100G-EPON wavelength plan comparison Model Discussion and Optimization

Dekun Liu

Two hypothetical wavelength plan

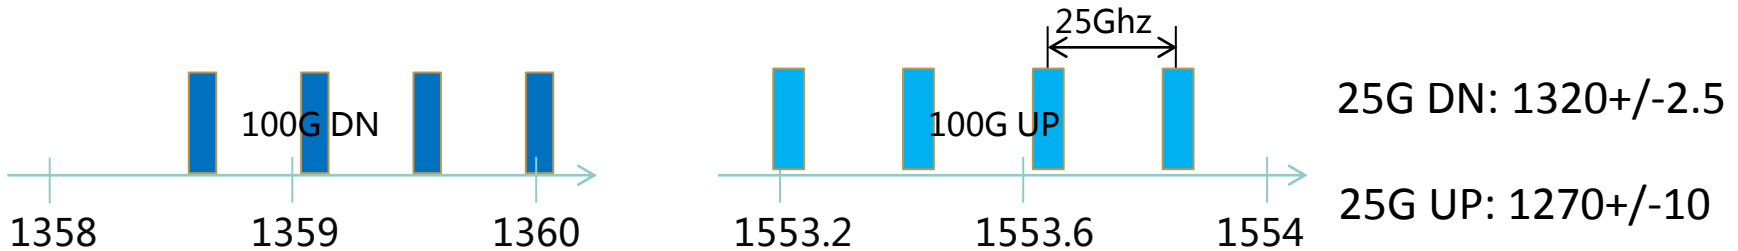
Two most difficult plans (G & H) get the best scores!
